Terex Utilities

Product Advisory

PA 1016C

SUBJECT: TURNTABLE BEARING BOLT INSPECTION (ALL UNITS)

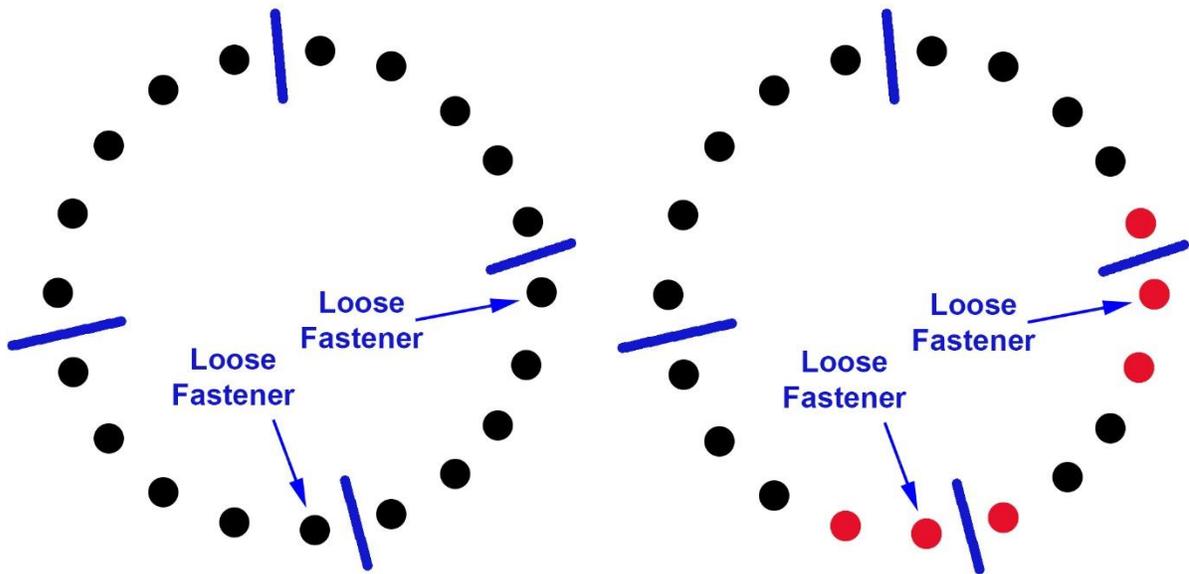
Daily visual inspection is looking for:

- Missing or broken fasteners.
- Loose washers or gaps under fastener heads.
- Indications of looseness such as shiny areas on washer or mounting surfaces.

If any of the above are observed do not continue operation. Notify the appropriate people in your company and have the machine repaired, it is not safe to use. Check the torque on all bearing fasteners and correct as required.

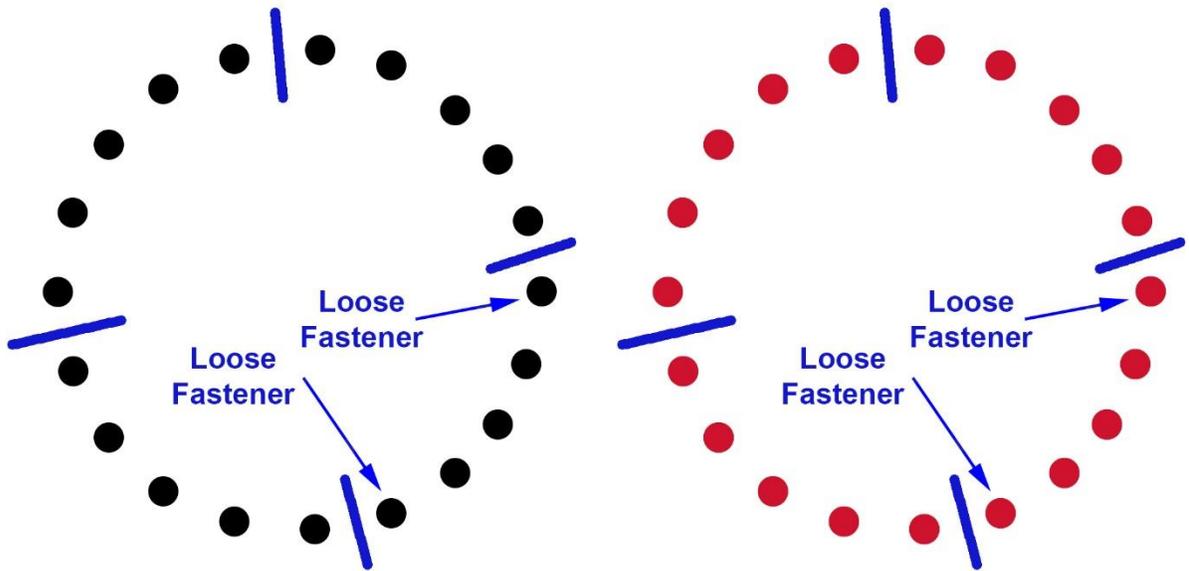
Loose fasteners are in different quadrants, replace each fastener and the fastener on both sides.

Both loose fasteners are in the same quadrant. Replace all fasteners in the ring.

- If 2 or more individual fasteners do not hold torque or move more than allowed each must be removed and replaced. Also the fasteners on each side of these fasteners must be replaced. If the 2 loose fasteners are in the same 90 degree quadrant, then all of the fasteners in the ring must be replaced.

For example, if there are 20 fasteners in the upper rotation bearing ring, then the loose fasteners must have at least 4 fasteners between any loose fasteners that hold torque.
